BANORA POINT UPGRADE ALLIANCE

BANORA POINT UPGRADE INDEPENDENT REVIEW OF BLASTING PROPOSAL

Adrian J. Moore
16th December, 2010

Figure 1 – Logarithmic distance/vibration relationship

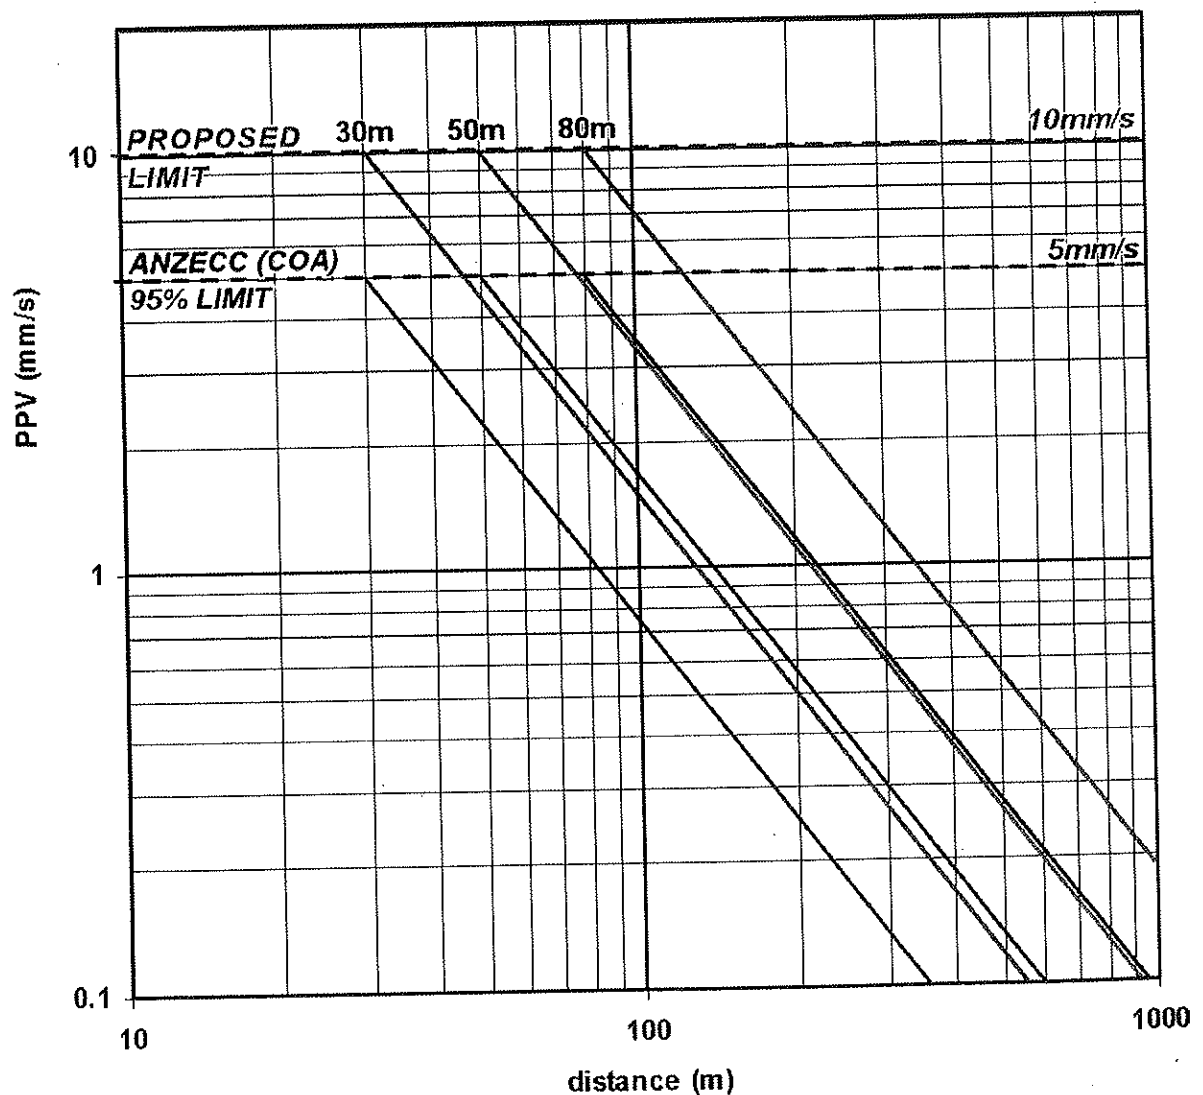
The effect of the increase of PPV from 5mm/s (95%) to 10mm/s (95%) can be shown graphically. The logarithmic distance/vibration relationship is shown in **Figure 1**.

If the CoA limit of 5mm/s at 50m is lifted to 10mm/s at 50m, the net affect is to extend the 5mm/s intercept to about 76m. If the 5mm/s limit at 30m is raised to 10mm/s, the 5 mm/s intercept extends to 45m.

Figure 2 – Transient Guide Values for Cosmetic Damage (BS7385-2)

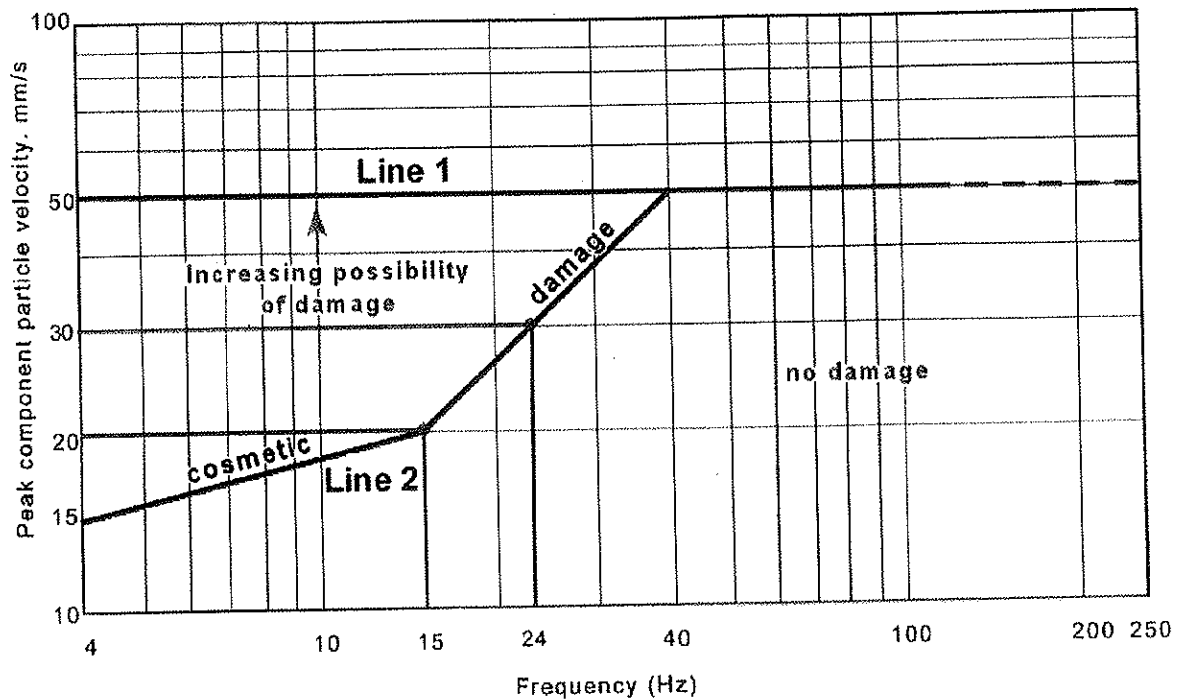
The authoritative references on the potential for damage to structures are the frequency dependant criteria of either British Standard BS7385-1:1900 or United States Bureau of Mines (USBM) Damage Criteria. Both are reproduced in AS2187.2 – 2006. Both are based on analysis of the same data, and give similar criteria. The USBM criteria may be mathematically purer in that the limit curve is based on either constant displacement or constant velocity lines. The *Transient Vibration Guide Values for Cosmetic Damage* (BS7385-2) is reproduced below in **Figure 2**. The PPV limits listed are peak component particle velocity [PCPV] (either of the two horizontal components or the vertical component) and not the Peak Vector Particle Velocity [PVPC]. If the PVPC is applied as a limit, there is an inbuilt element of conservatism, e.g. three equal components near 20mm/s would equate to a PVPC of 34.6mm/s.

From damage observations, cosmetic damage to houses begins to occur when the PPV levels exceed Line 2. The Damage classification is shown in Table 1.

The BPUA modification request limit of 10mm/s is well below damage classification criteria limits.

Figure 5 – Schematic Loading

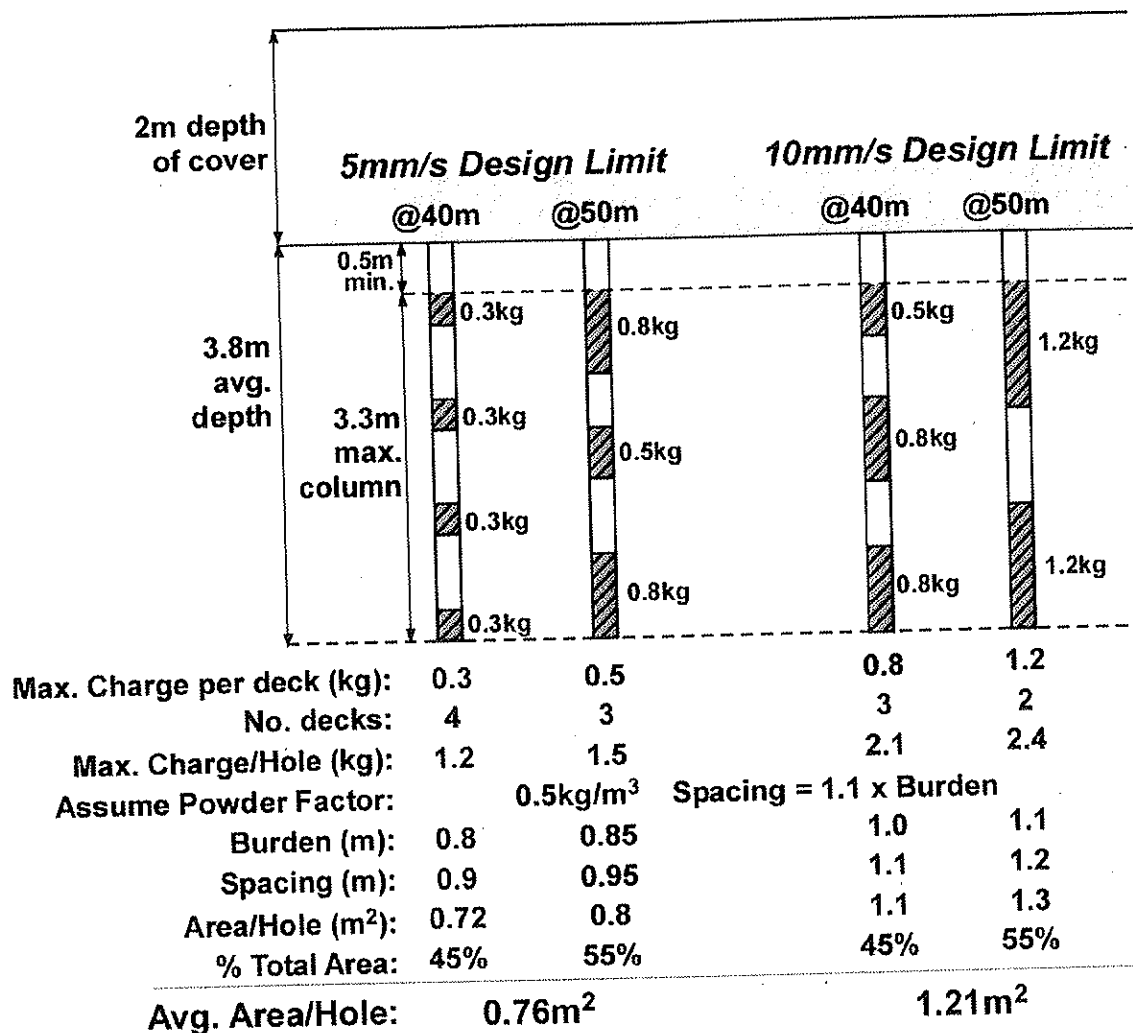
To determine the number of holes required to blast the 5700m², a number of assumptions are made regarding loading as illustrated in **Figure 5** below.

Figure 4 shows the 30m and 50m radii drawn from the 5 houses that will determine the limiting blasting design. The blue coloured area is 50m plus, the purple area 30-50m and the green area less than 30m from the houses. The number of holes required to be drilled can be determined from the limiting blast design for each area to achieve 5mm/s and 10mm/s limits. If it assumed that the loading at 50m applies over the blue area, and a loading of 0.5 kg/m³ and thereby the number of holes can be calculated, as shown in **Figure 5**.

Avg. depth	3.8m
Avg. area to be blasted	5700m ²
@ 5 mm/s, No. holes @ 0.8m ² /hole	7125 holes
@ 10 mm/s, No. holes @ 1.2m ² /hole	4750 holes
Hole reduction =	2375 holes
% hole reduction =	$\frac{2375}{7125} = 33\%$

The number of holes by this approach (4750) is within 10% of the number of holes calculated by the BPUA approach (4320) which is considered to be close enough for the type of calculations made.

Based on the assumptions made, the 33% reduction indicated in the approach outlined is much greater than the 24% reduction listed in the BPUA Request.
